Addendum No. 2

Truckee Meadows Water Authority Corporate Accessory Storage Building Addition

PWP Bid No. WA-2014-311

September 17, 2014

TYPICAL MASONRY WALL REINF $\frac{10}{S0.2}$

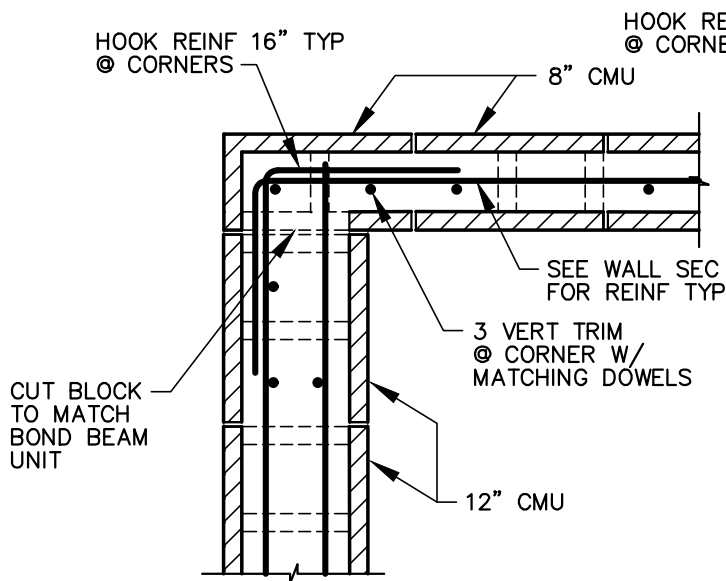
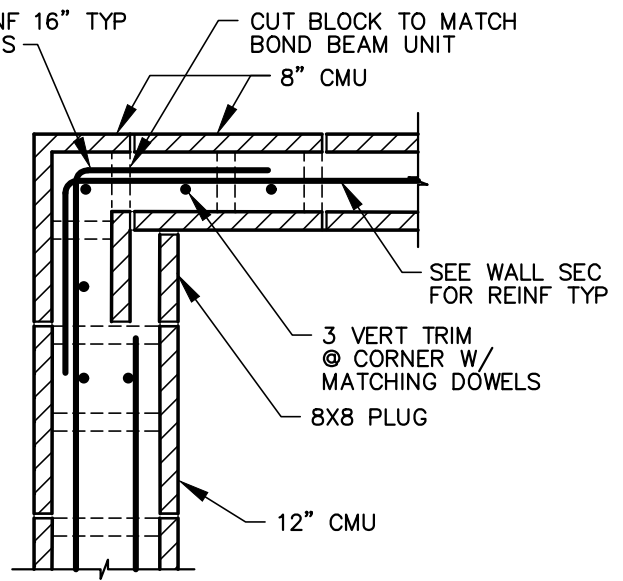
Clarification No. 1: For northwest and southwest corner of CMU walls, please revise detail 10/S0.2 per the attached Sketch SK-1. This will revise Elevation 5/A2.1 to extend the running bond cmu coursing all the way to the northwest corner.

1. ALL TRIM REINF TO MATCH SIZE OF WALL REINF.
2. USE 24" X 24" CORNER BARS IN LIEU OF THE 16" HORIZONTAL HOOKED BARS.
3. LAP SPLICES PER TYPICAL REINFORCEMENT DETAILS.
